Radio Mods Database

<http://www.kb2ljj.com>

## TS-950 Mods

ORIGINAL

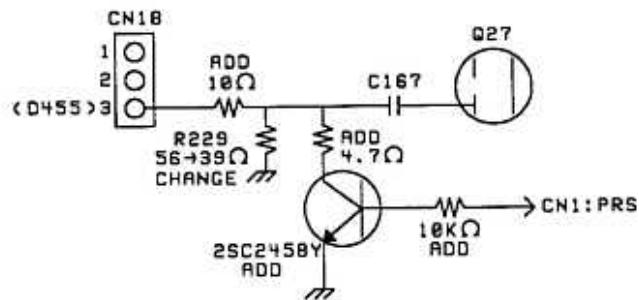
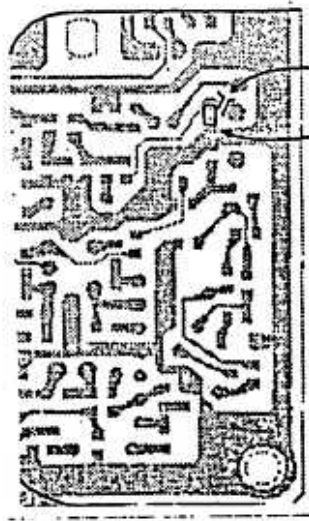
When the Processor-In control is set to some level below 10 dB of compression, a crackling noise can be induced on the transmit signal. The following modification will reduce the noise. After the modification has been performed, the noise can only be heard when the Processor-In control is set too low to be functional.

Desolder and remove R229.

Solder a 10 Kohm resistor to the circuit as shown.

REMOVE  
R229ADD 10 OHM  
INSTALL R229ADD 4.7 OHM  
W4ADD 10K OHM  
ADD 2SC2458Y

FIGURE 1

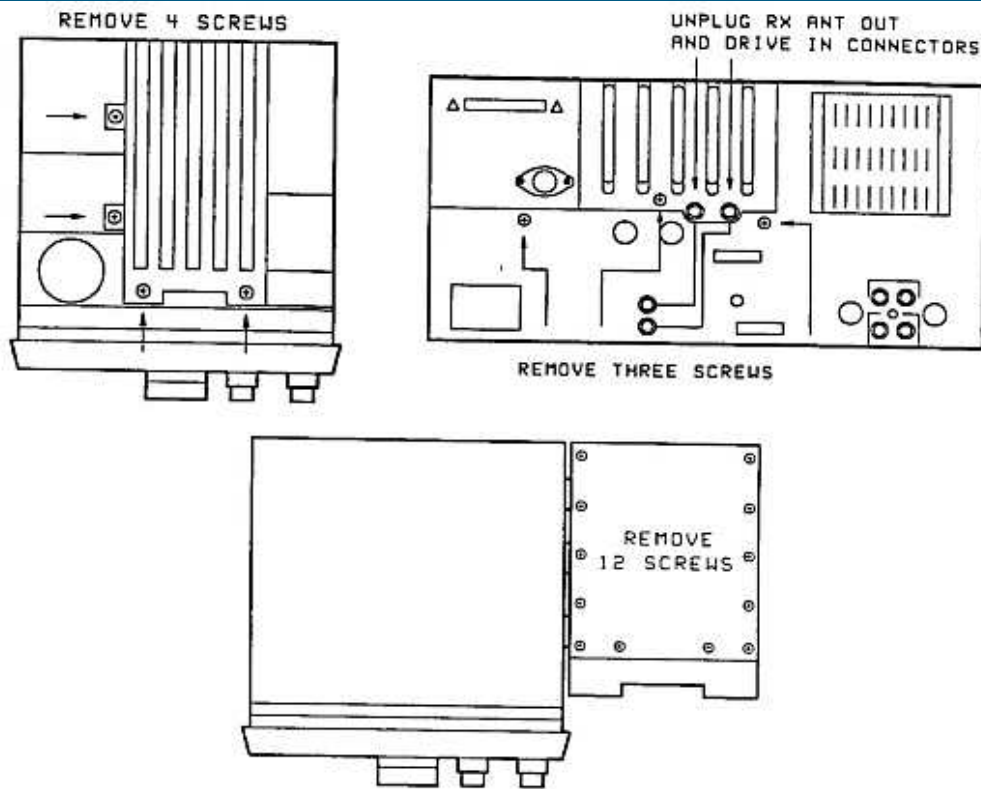
Open the sub chassis as shown in figure 1 (remove 4 top screws, remove 3 back panel screws, unplug the RX ANT OUT and DRIVE IN connectors).

Remove the cover from the sub chassis (12 screws). Figure 1.

FIGURE 2

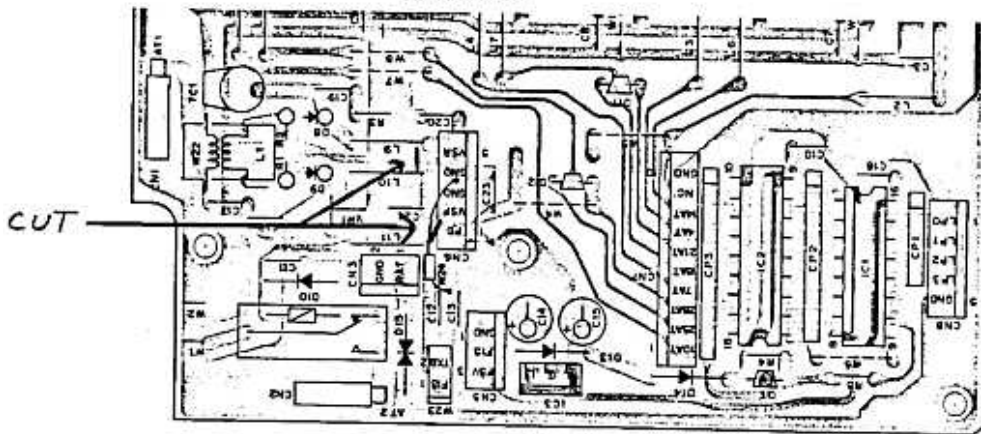
Cut the two foils as shown in figure 2.

FIGURE 1

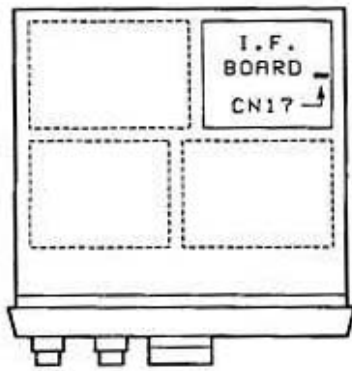
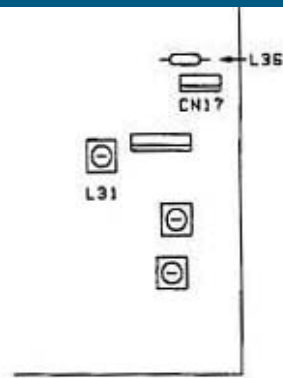
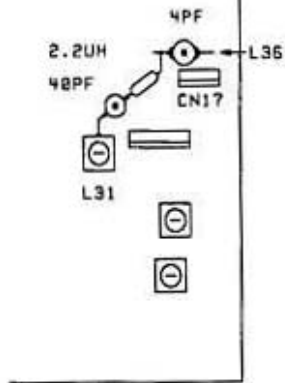
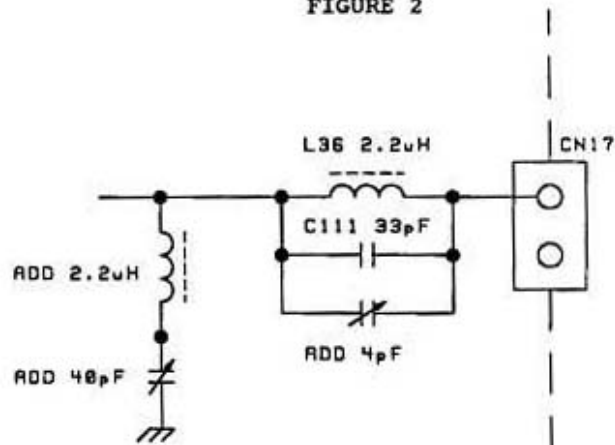
Some TS-950SD owners have reported a transmit image at 18.115 MHz that cause the receiving station to hear distortion on the carrier. If the operating frequency is shift 3 KHz above or below 18.115 MHz, the image disappears. This modification will lower the image level from -30 dB (worse case) to better then - 40 dB by installing a trap on the 455 KHz I.F.

Locate the I.F. board on the bottom of the transceiver. This is the back right board of the 4 boards on the bottom of the transceiver. Figure 1.

Locate L36 by connector CN17 on the I.F. board. Figure 2.

Install and solder into place a 4 pF trimmer capacitor across L36. Figure 3.

Install a 2.2  $\mu$ H coil and 40 pF trimmer capacitor in series from the output of L36 to ground. The can of L31 can be used for ground. Figure 3.

(Figure 2)

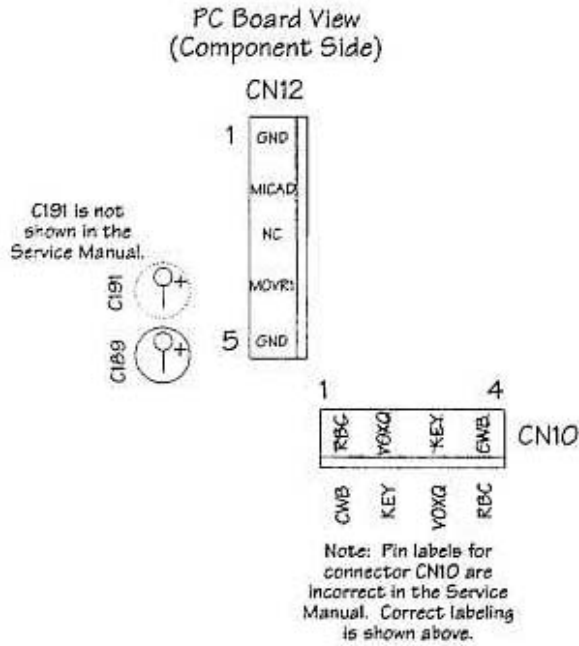
Add C191 in the position indicated in figure 2.

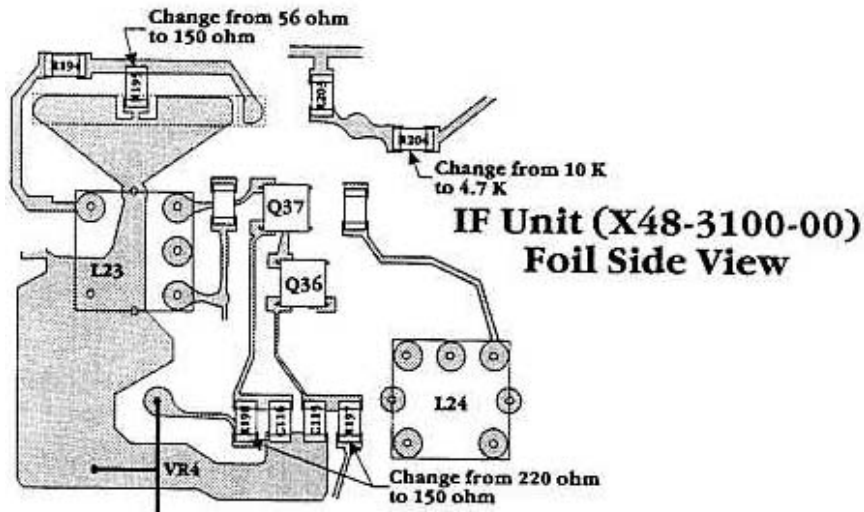
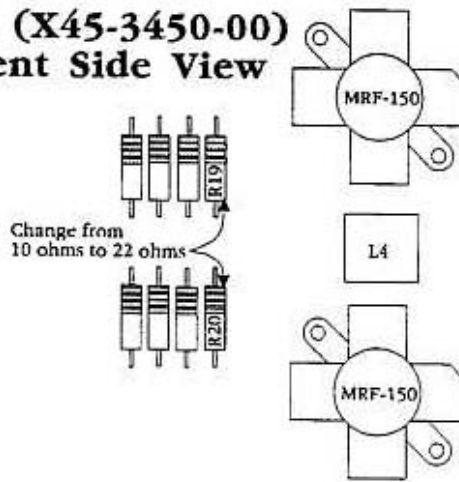
On the Final unit (X54-3450-00) change R19 and R20 from 10 ohm to 22 ohm. Figure 1.

On the IF unit (X48-3100-00): Figure 2.

- Change R195 from 56 ohm to 150 ohm.
- Change R197 from 220 ohm to 150 ohm.
- Change R198 from 220 ohm to 150 ohm.
- Change R204 from 10 Kohm to 4.7 Kohm.

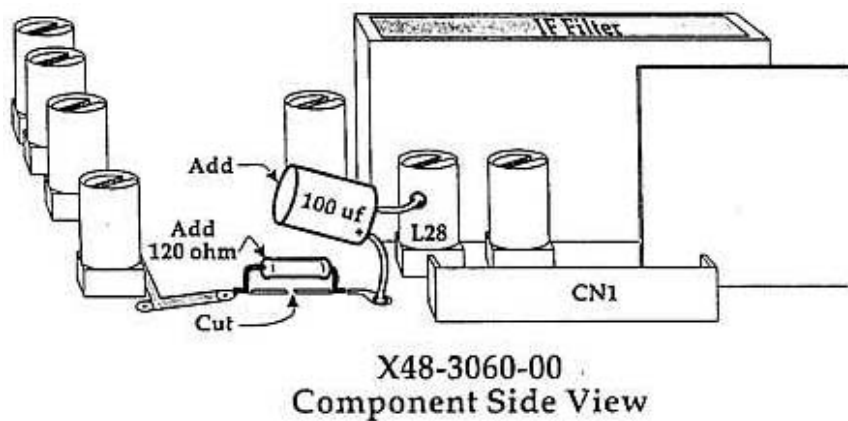
Switching noise from the noise-blanker gate enters the AF amplifier via the +15 V line causing the noise.

Cut the pattern of the 15 V line on the IF unit (X48-3060-00) component side, near Q34's emitter and add the 120 ohm resistor as shown in the accompanying diagram.

Add the electrolytic capacitor as shown in the diagram. Quickly solder the negative lead to the metal shield of L28.

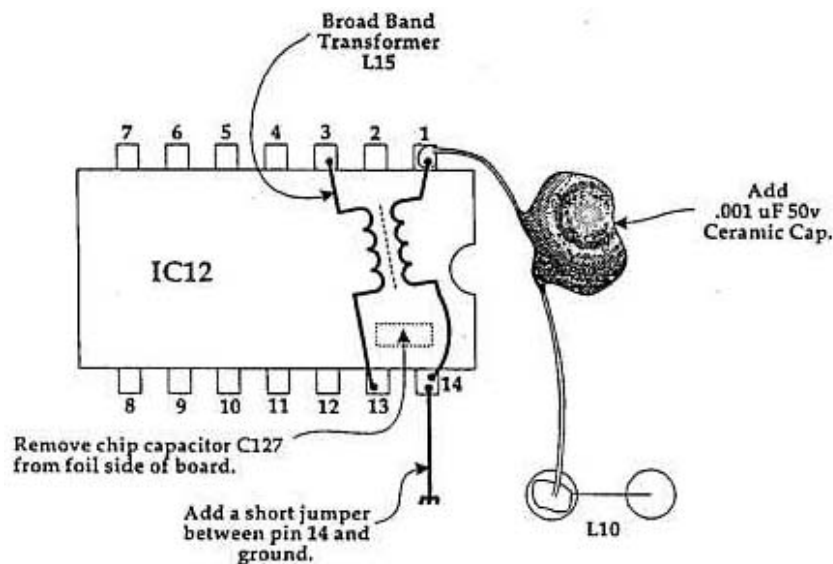
Solder the primary of the transformer to pins 3 and 13 of IC12. You will have to bend the terminals slightly.

Solder the secondary of the transformer to pin 1 and 14 of IC12.

Remove chip capacitor C127 from the foil side of the board.

Add the new C127 from pin 1 of IC12 to L10 as shown in the accompanying illustration.

AF Unit (X49-3020-00)  
Foil Side View

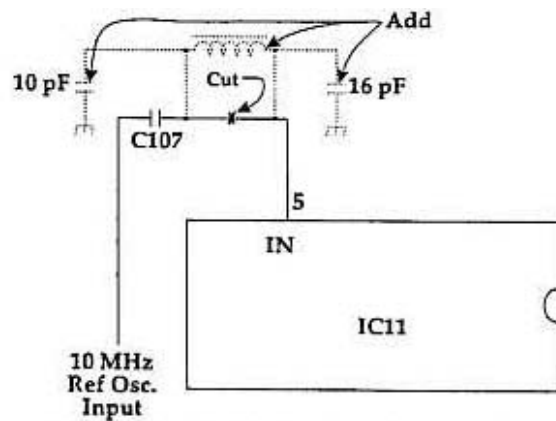
The transmitted signal enters pin 5 of IC11 which is in the last PLL loop in the AF unit due to RF feedback. This pin is the input for the 10 MHz Ref. Osc. signal from the CAR unit. IC11 is the source of the spurious signal since both the band and 10 MHz frequencies are divided by the 500 KHz comparison frequency supplies by IC11.

**Correct action:** To reduce this RF feedback increase the Ref. Osc. level from .2 V to .7 V ms by adding the accompanying circuit to the input of IC11.

FIGURE 1

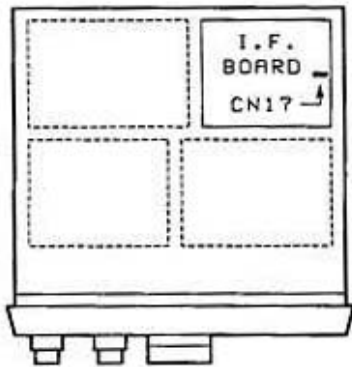
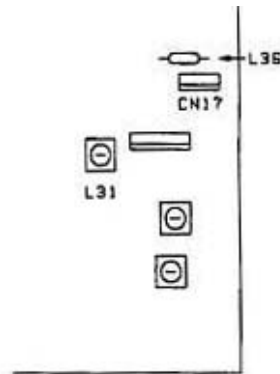
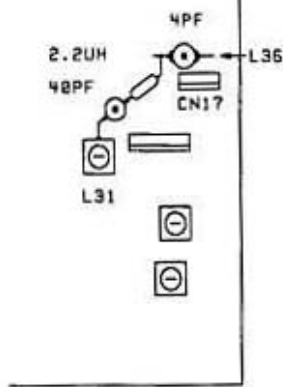
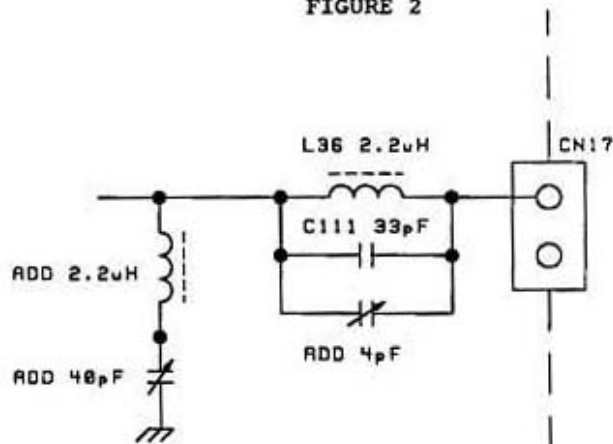
**Corrective Action:** Add the low pass filter shown in the accompanying diagram to the input circuit of mixer Q41 on the IF unit (X48-3060-00). This filter will increase the attenuation by approximately 20 dB.

Signal unit pc board (X57-3380-00), Bottom OF TS-950SD

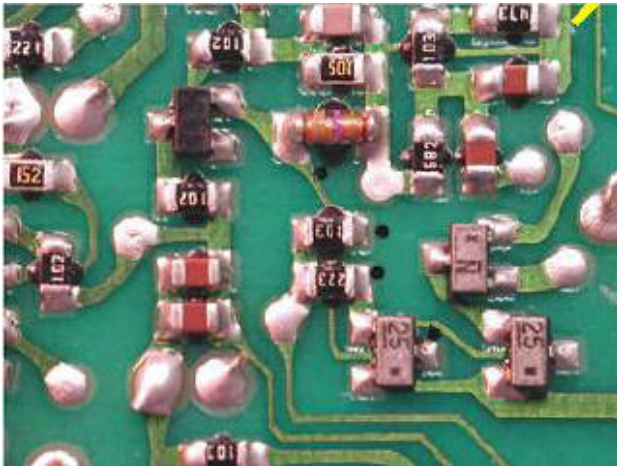
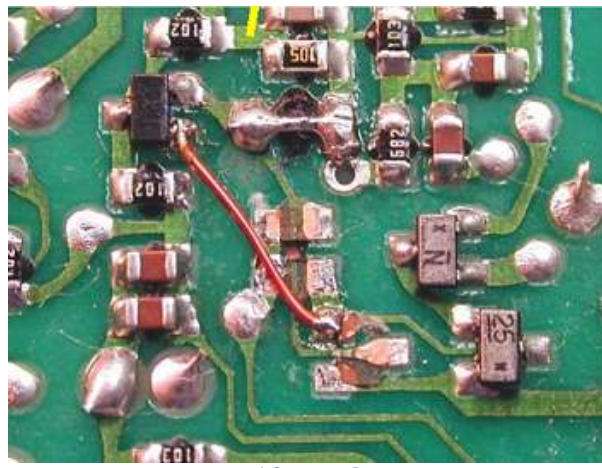
Cause: Insufficient study on switching transistors Q 30 and Q 40 (these transistors operate at AGC OFF) of AGC amplifier Q 10 in the signal unit.

Countermeasure: The circuit of the AGC amplifier Q 10 is the signal unit (X57-3380-00) is modified.

Chip resistor R 135, it removed.

Chip resistor R 136, is removed.

Digital transistor Q 40, DTC124EK, is removed.

Short jumper W9, R92-1061-05, is added.
